Response to Submissions Section 75W to Concept Plan (MP10_0229)

Woollooware Bay Town Centre

Residential Precinct GFA/GBA and Building Envelope Amendments

Submitted to Department of Planning and Environment
On Behalf of Bluestone Capital Ventures No. 1

Figure 1 – Proposed separation distances

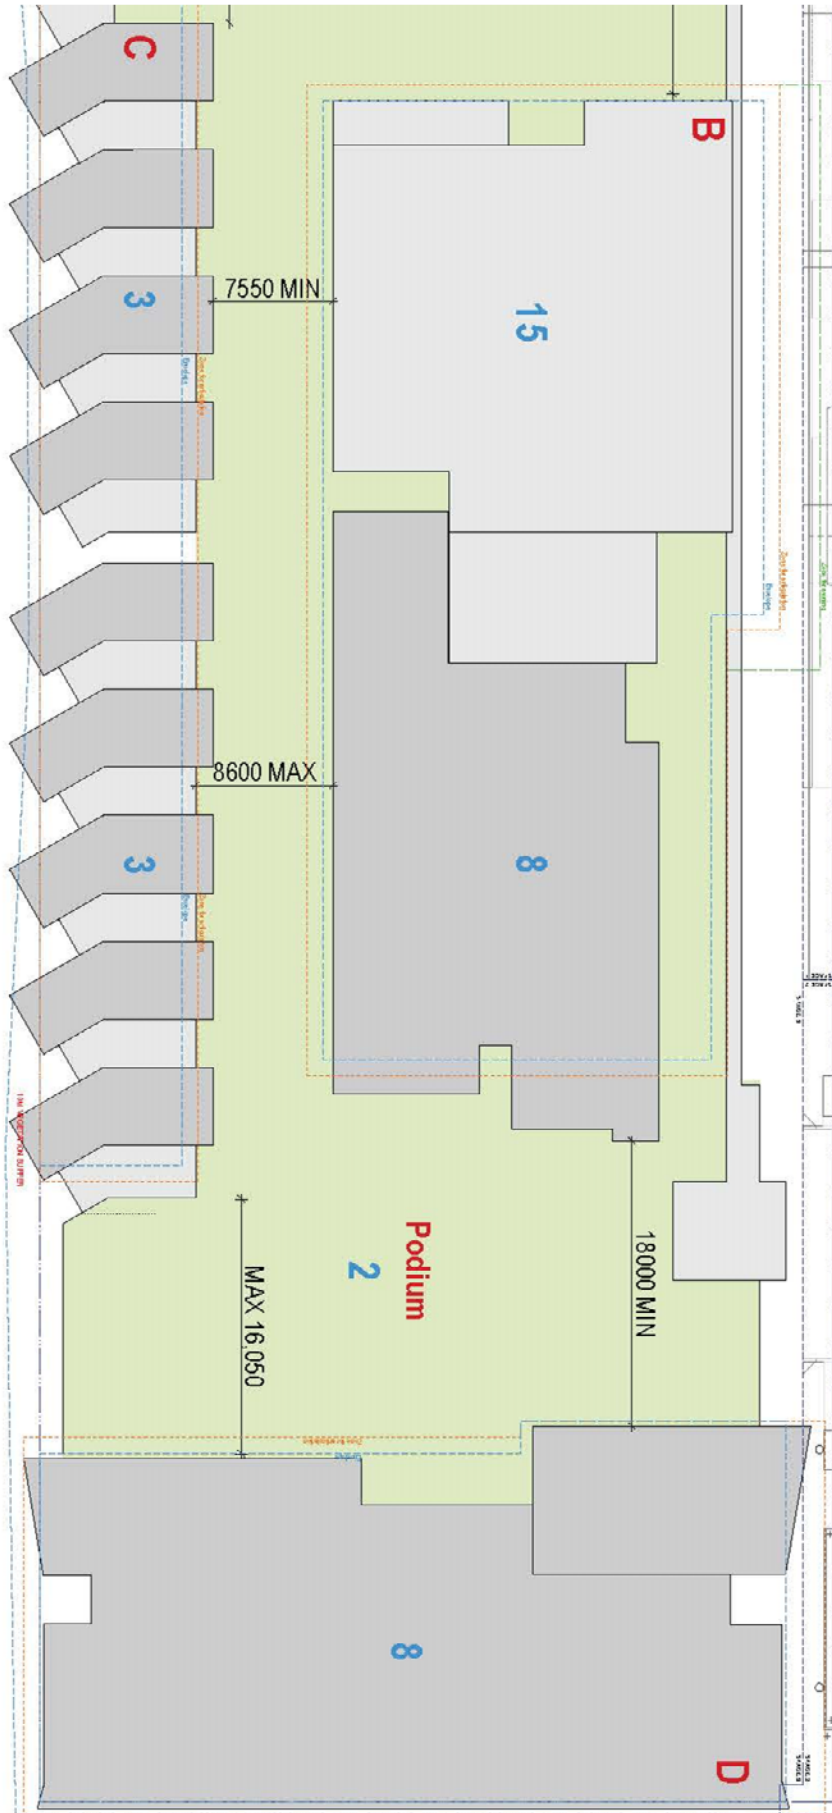
Council specifically raised no objection to the minor envelope amendments, provided that they enhanced the residential amenity of the future apartments. It was suggested by Council that the proposed amendments to Buildings B and C would result in non-compliances with the separation distances prescribed in the Apartment Design Guide (ADG). The result of this was suggested to be apartments with compromised privacy, solar access and ventilation.

The clarifications and schedules requested by the Department are addressed in detail at Section 4.0. Council's suggestion that the proposed amendments to the building envelopes will result in separation distances not strictly compliant with the ADG design criteria for Objective 3F-1 is partially correct. **Figure 1** illustrates the separation distances of the envelopes within Stage 3.

As evidenced in **Figure 1**, all separation distances are numerically compliant with the design criteria of the ADG, except for the distance between Buildings B and C. Despite not strictly achieving the numerical design criteria for Objective 3F-1, the proposal is still consistent with the objective itself. Objective 3F-1 states:

As the proposal does not numerically comply with the design criteria for Objective 3F-1, an alternative solution has been adopted to achieve compliance with the objective. The ADG acknowledges the difficulty in achieving rigid numerical standard in all instances. As such, a set of design guidance are provided as a starting point for any alternative solution. Two of the design guidance are relevant to the proposed development, being the need to avoid direct lines of sight for windows and balconies across corners and no separation is required between blank walls. Importantly, no windows are expected to be provided on the elevation of Building C facing Building B, ensuring all potential privacy impacts are mitigated. These design guidance are achieved as illustrated in the section of Buildings B and C provided at **Figure 2**.

Figure 5 – Expected shuttle bus route

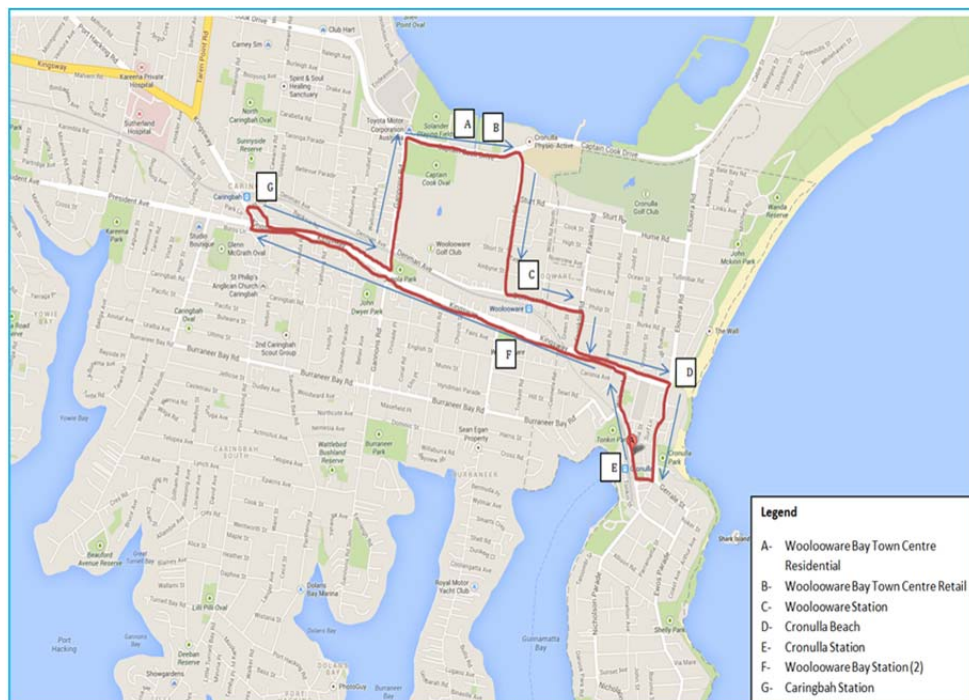
A number of queries were raised in relation to the size and function of the shuttle bus. Sutherland Shire Council stated the following:

The concept approval requires provision of a shuttle mini-bus service connecting with local train stations

The Concept Plan requires that a shuttle bus be provided, but the size and capacity of this bus was never stipulated. The Development Consents for Stages 1 and 2 of the residential precinct require a minimum capacity of 22 seats. This minimum capacity was based on expected demand assessments undertaken by McLaren Traffic Engineering. It is clarified that the shuttle bus is not to be a 'mini-bus', but rather a full size bus with capacity for 50-53 seats and room for 17 standing passenger. This bus will provide more than double the capacity than previously expected to be required to accommodate the demand of the precinct.

The proponent is currently in discussion with Transdev to operate the shuttle bus, linking Woollooware Bay to the public transport nodes of Woollooware Station, Caringbah Station, Cronulla Station, Cronulla Beach and a second stop on The Kingsway to service Woollooware Station. **Figure 5** illustrates the preferred route which is still subject to amendment following the ongoing discussions with Transdev.

Given the scale of the bus and the expected minimal population increase resulting from the proposed Modification Application, it is considered there will be sufficient capacity for future residents to access the nearby heavy rail network. In due course, once demand has been established through the occupation of the residential precinct in Woollooware Bay, it is expected that Transport for New South Wales will begin to operate a public bus along this general route, consistent with the discussions held during the assessment of the original Concept Plan.
